# NORTHUMBERLAND DEVELOPMENT PROJECT **HOTEL**

**S73 APPLICATION**

THHTL-F3A-XX-XX-RP-A-0006

**DESIGN AND ACCESS STATEMENT ADDENDUM UPDATE**

**FIGURE 28.** Proposed Scheme Revision - Roof (Screen) General Arrangement Plan

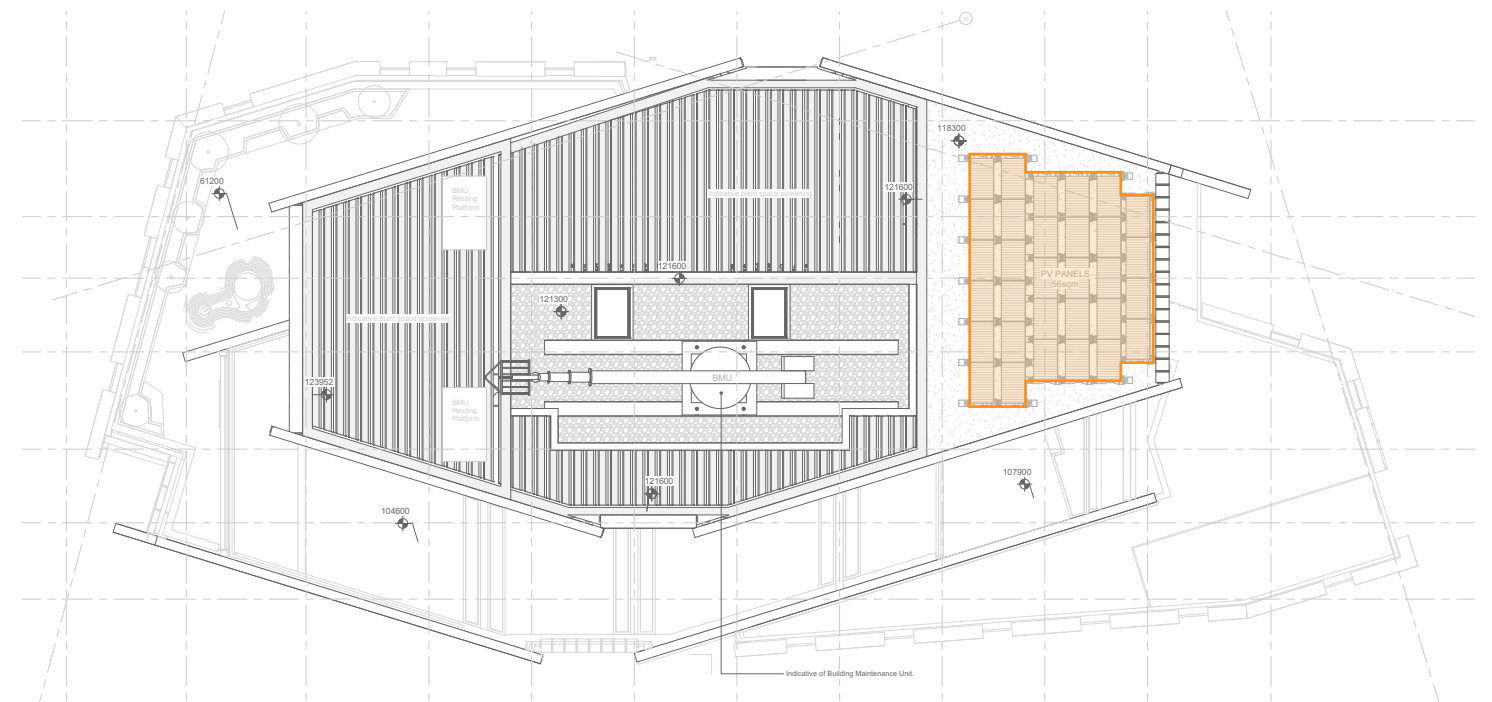
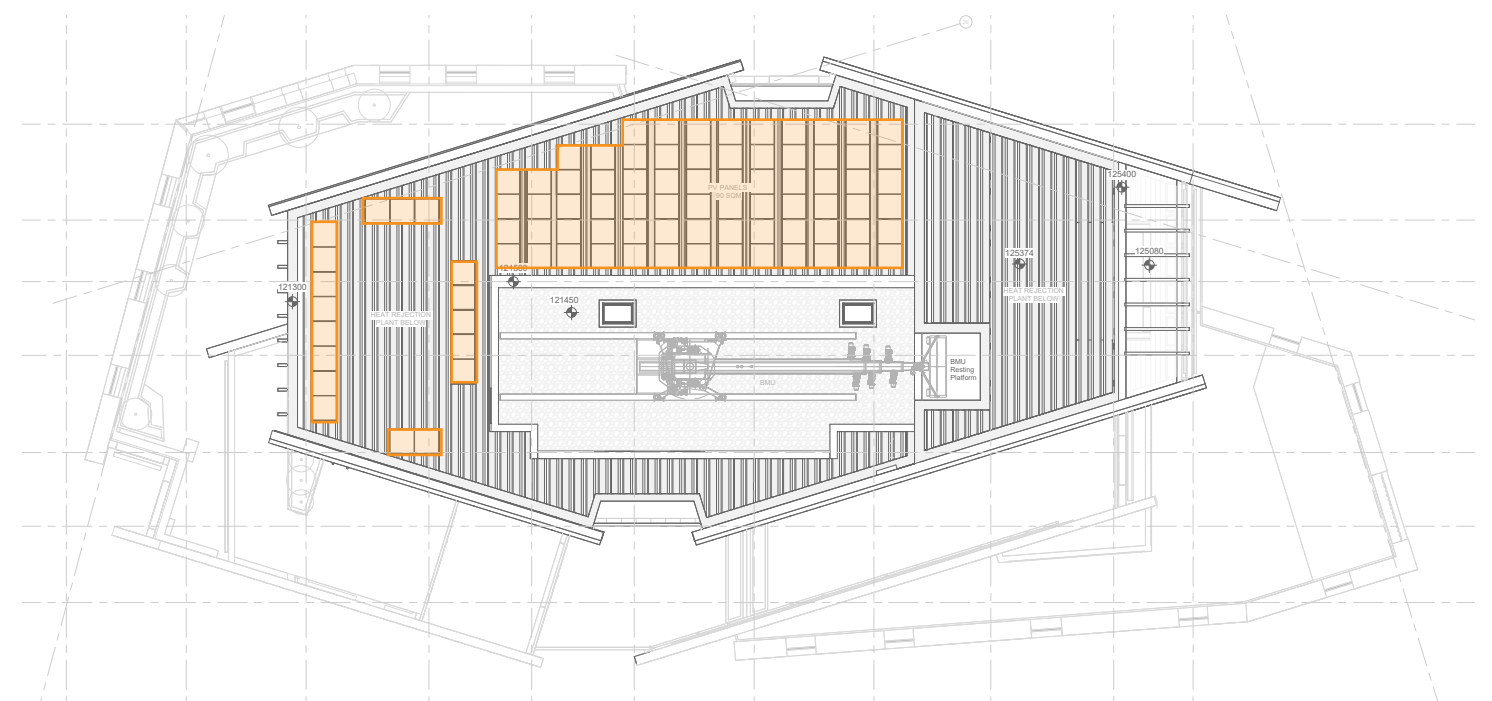
- Recommendation for photovoltaic panels to be added to canopy roof to increase renewable energy production.

- Improved renewable energy production.
- Panels not impacting on potential for increased residential Gross Internal Area.
- C. 90sqm of photovoltaic panels (additional c.30sqm).

**FIGURE 32.** Proposed Scheme Revision - View from High Road and Park Lane Junction

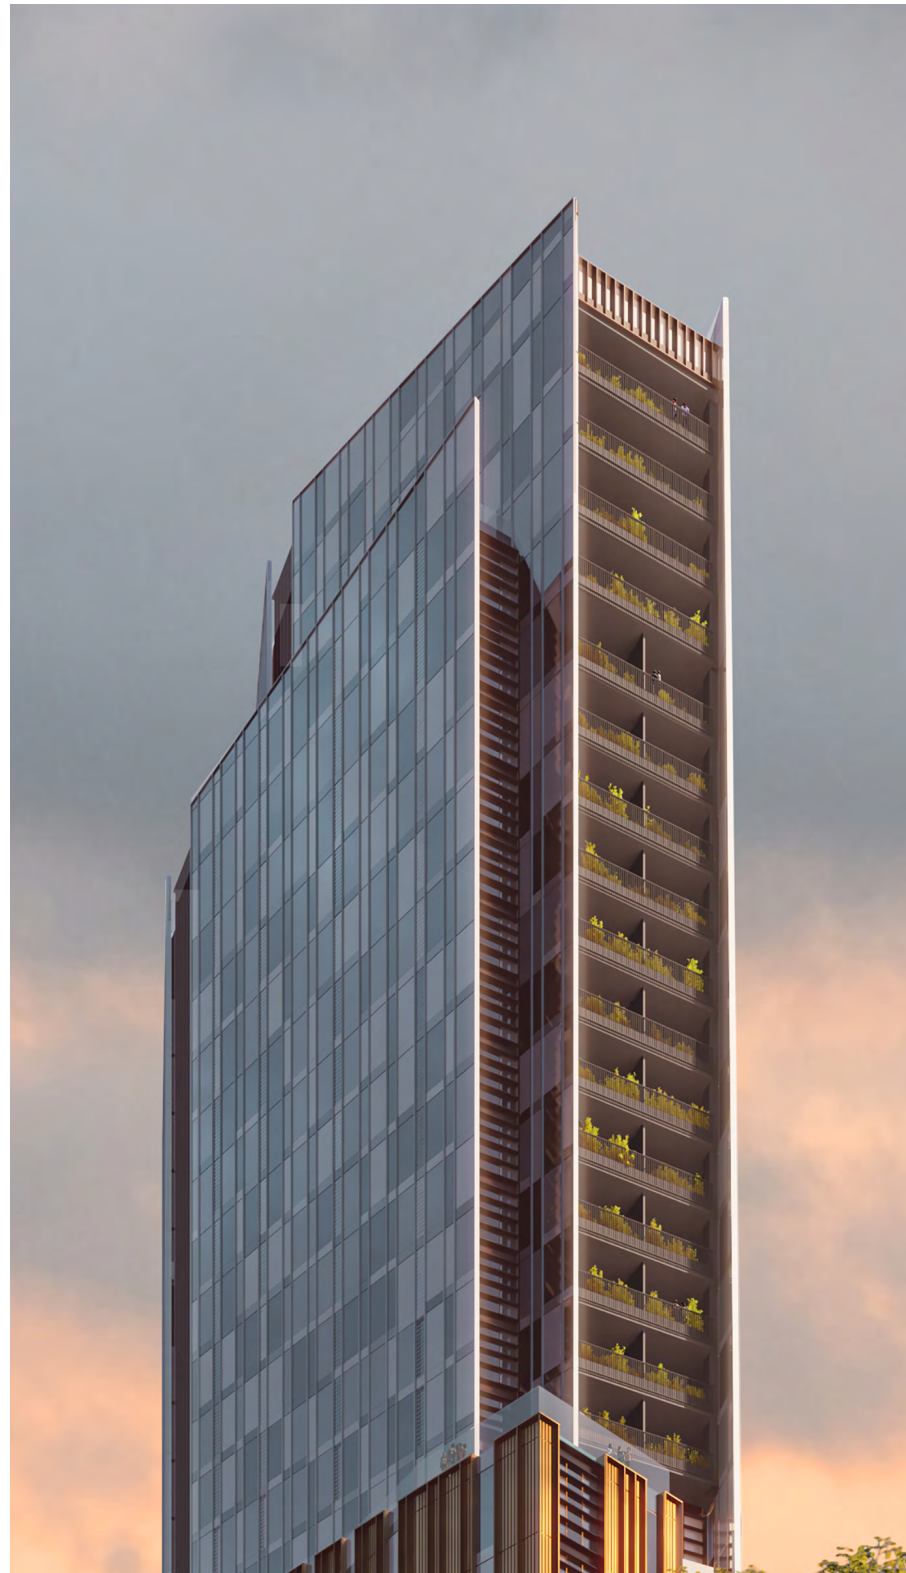
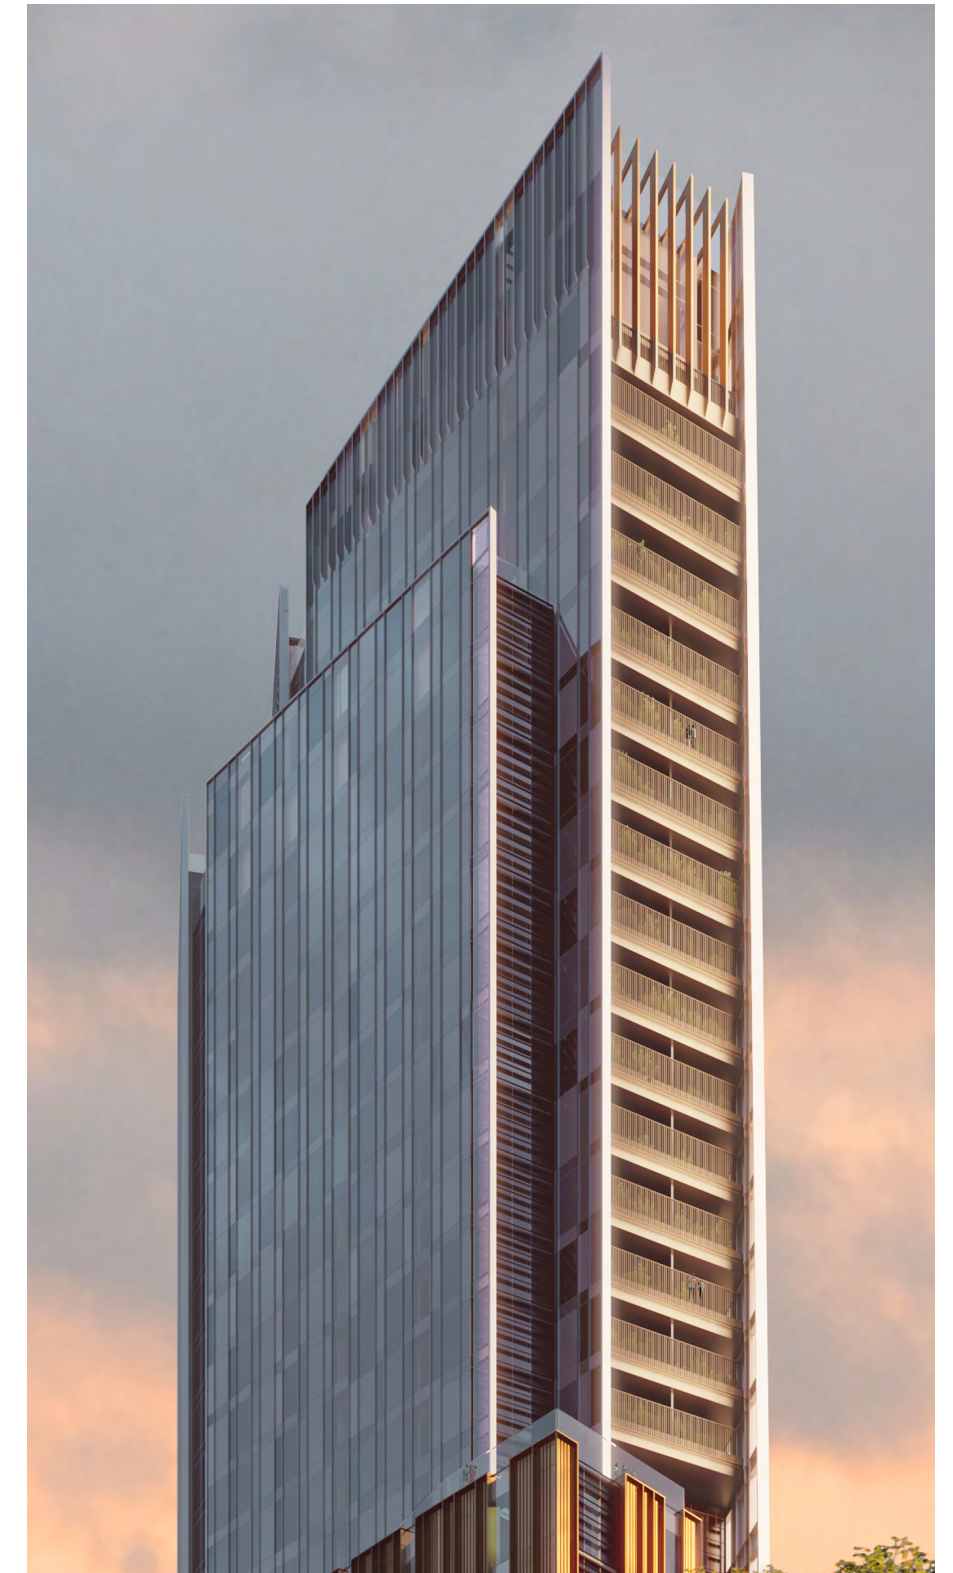
- Balconies must further accentuate the slenderness of the building, and provide a 'jewel' to the top of the tower.

- Expression of the top of the tower and 'lantern' creating the desired spire like termination to the tower when viewed from the south along the High Road.
- Improved relationship in materiality and tonality between the top and base of the tower.
- Improved residential experience at penthouse levels, and creation of a residential hierarchy.

**FIGURE 33.** Proposed Scheme Revision - Wall Type 04 Recessed Infill Balconies Section

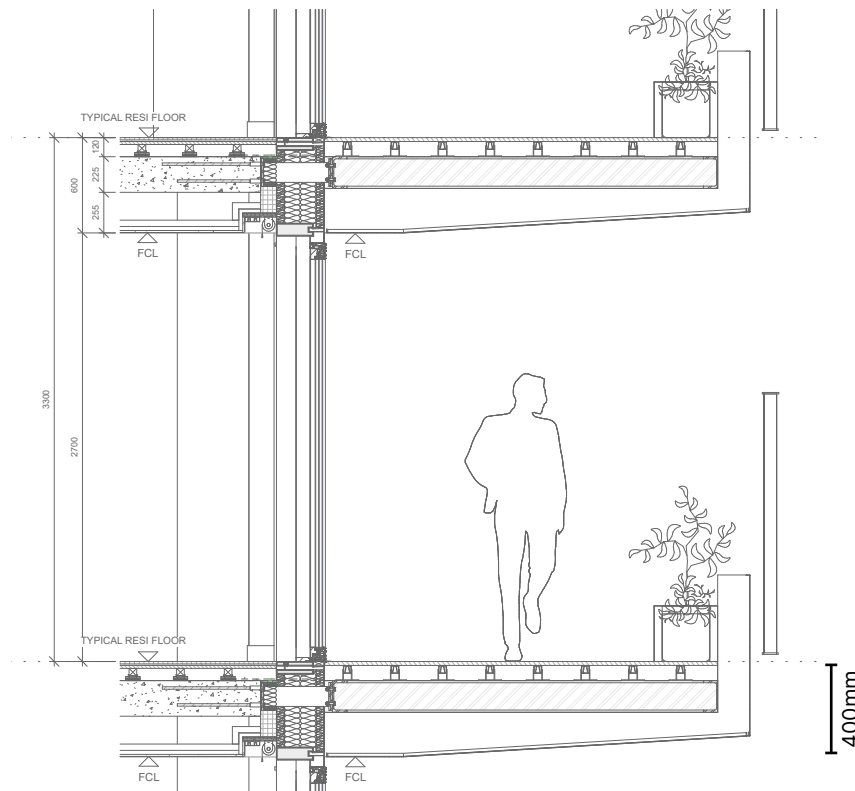
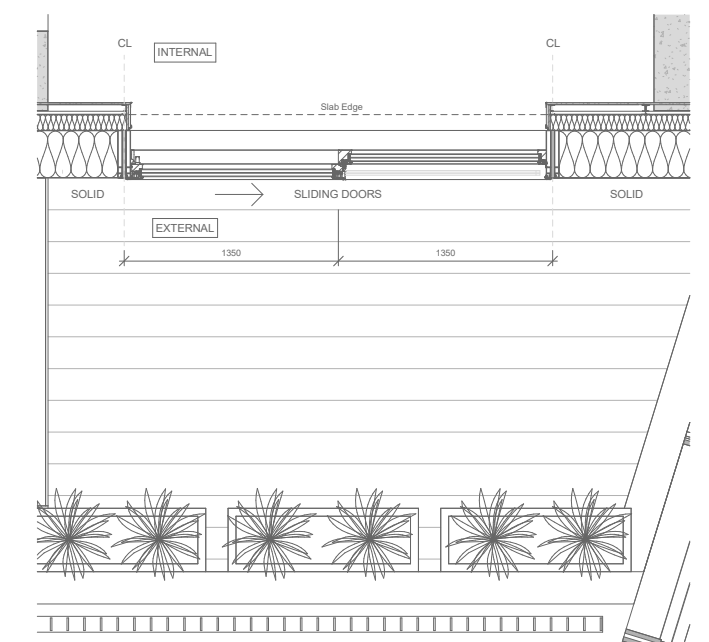
- Further information requested surrounding detail of planters and how these would sit within the balconies.

- More generous width for planting encouraged on the overhanging balconies so that residents are not restricted in making their amenity spaces greener.

- All residential balconies have a 400mm upstand to the inside of the balcony balustrade to conceal freestanding planters. All planters will be provided and maintained by residents.

- Allows residents flexibility to populate balconies with planters and vegetation of their choice.
- Concealing planters encourages greening of the façade, through overhanging vegetation. Planters remain hidden behind the upstand so as not to detract from the architectural expression of the building.

**FIGURE 41.** Proposed Scheme Revision - Wall Type 01 Planar Blade Sections

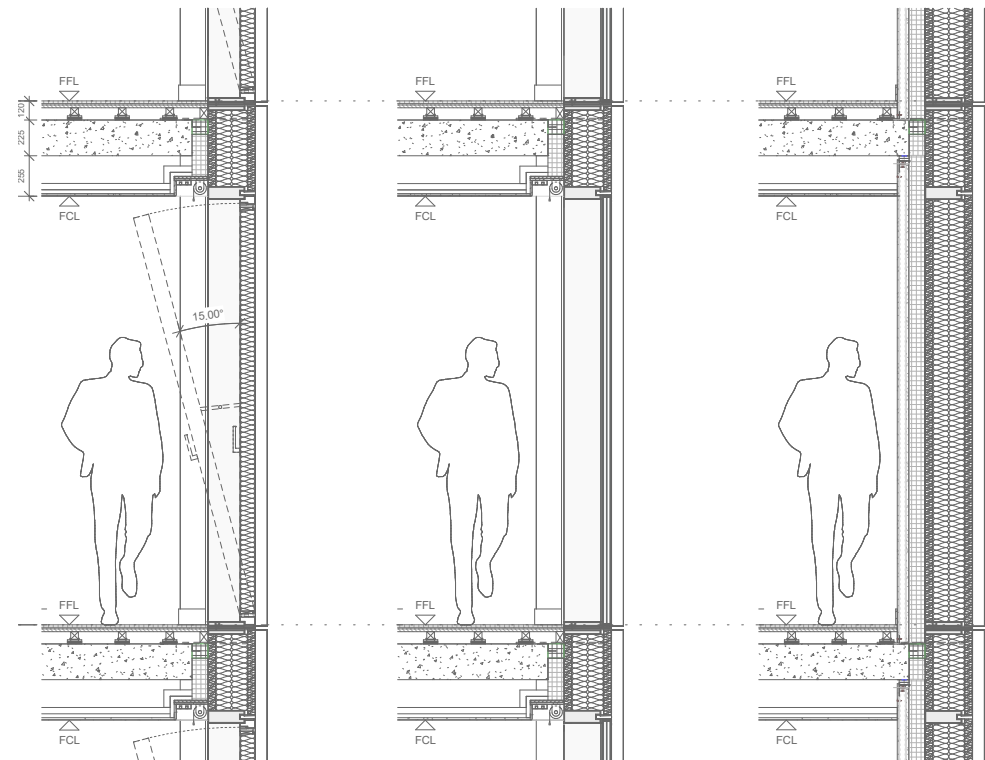
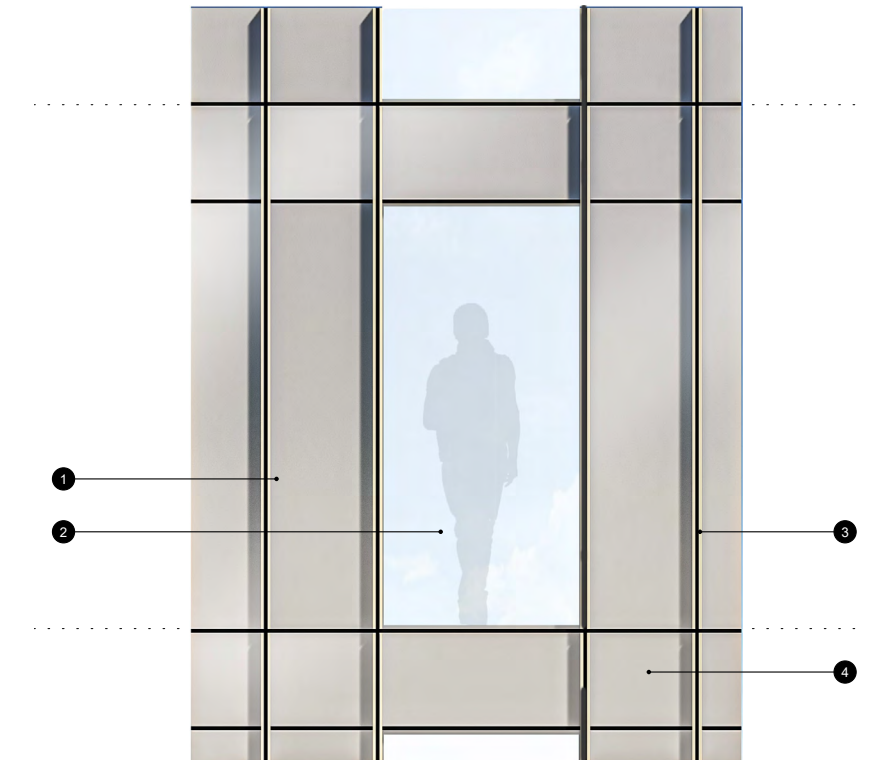
- Solid aluminium panels used in lieu of a curtain wall system to the 'planar blades'.
- Glazing used only where vision panels required, maximising insulation within build-ups for the remaining solid panels.
- The combination of polished, matte and brushed aluminium (anodised effect finish) panels to provide visual interest.
- All habitable rooms in the residences have solid openable panels to allow the option for all rooms to be naturally ventilated.
- All other wall types (e.g. recessed infills) have been rationalised, reducing the amount of glazing, and thermal bridging to improve overall building energy efficiency.

- Overall improvements to energy efficiency, U-value, and thermal bridging performance of the building, specifically where the envelope reaches residential floors.
- Overall improvements to the viability and constructibility of the scheme.
- Original design intent, principles, and aesthetic of the 'planar blades' maintained, as outlined in Section 5.7 of the Design and Access Statement Addendum.

**FIGURE 51.** Proposed Scheme Revision - Level 02-11 (Typical Hotel Floor) GA Plan

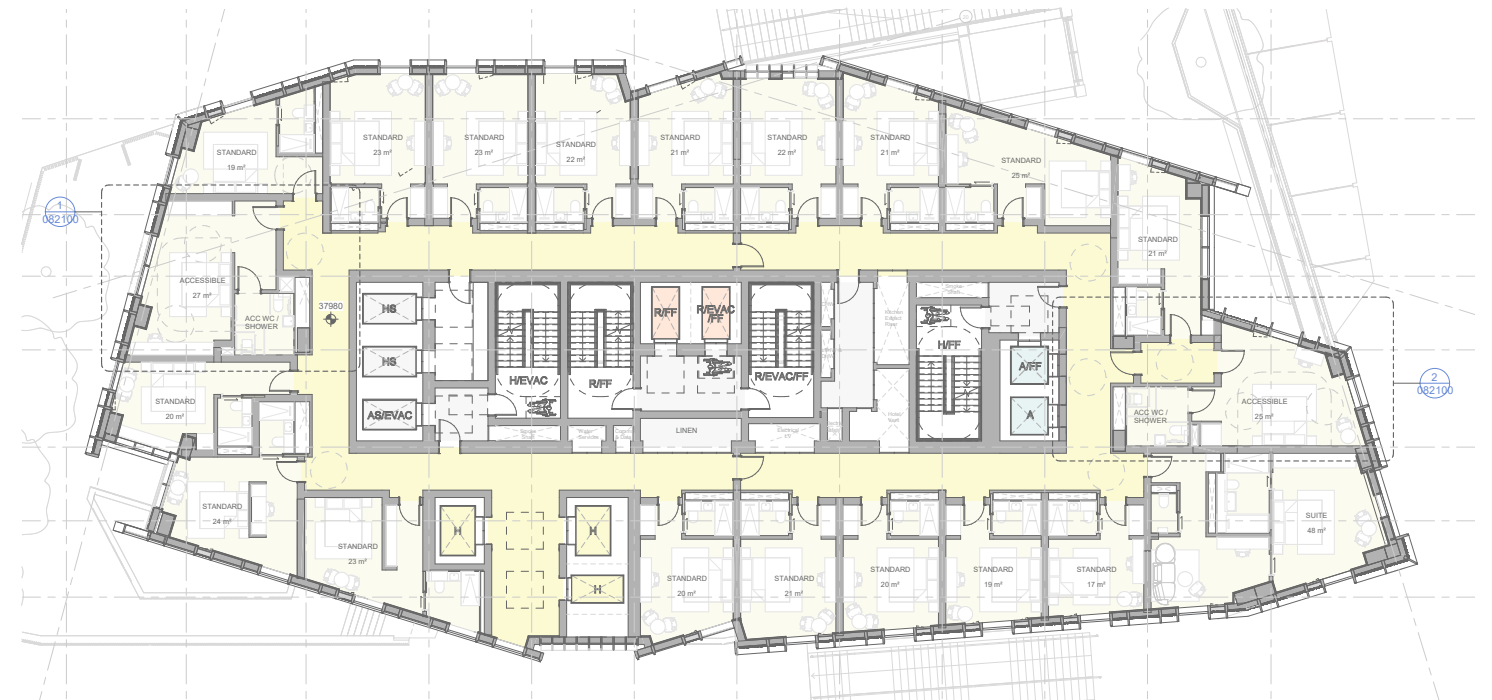
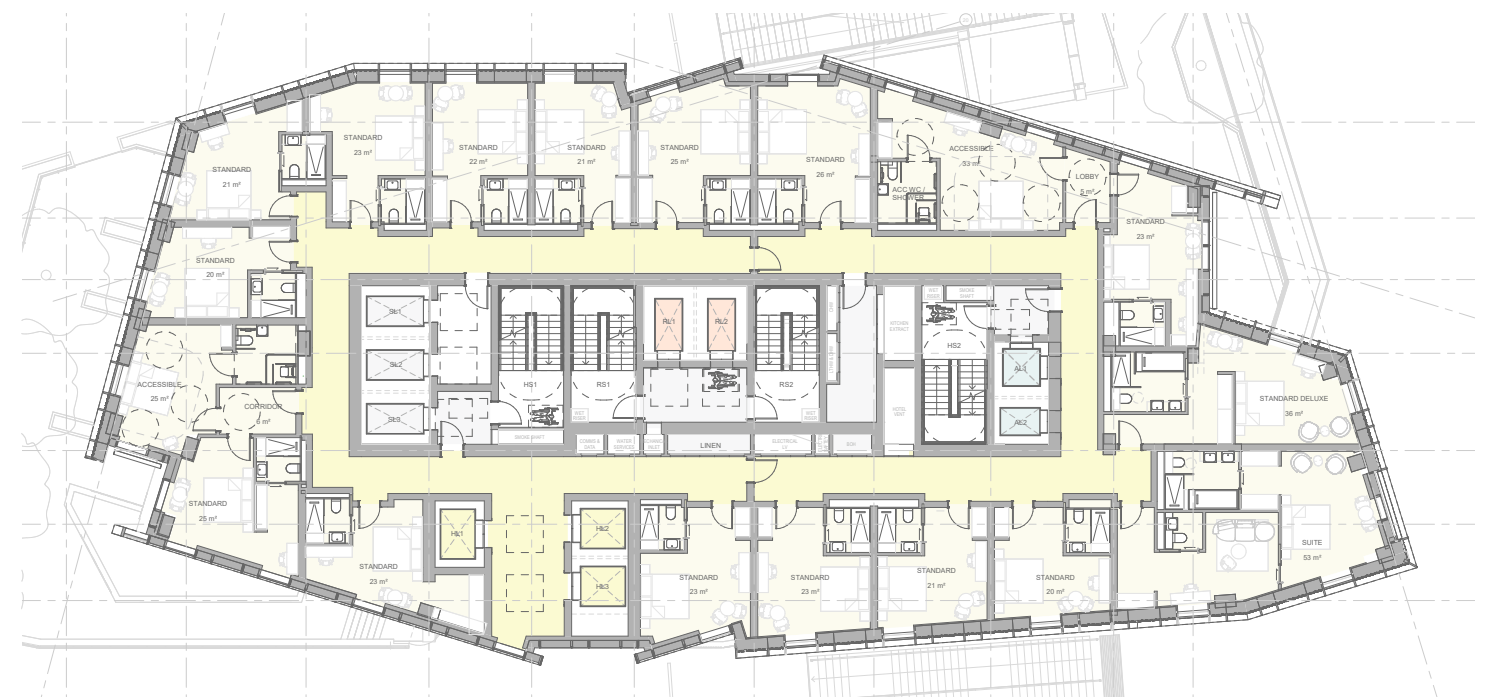
- E. Hotel and Hotel Amenity Floors** - The number of hotel rooms has been reduced from 20 to 18 rooms per floor (now spanning Levels 02-11), still accommodating a total of 180no. hotel rooms. Updates to hotel amenity layout provide improved hotel guest experience.
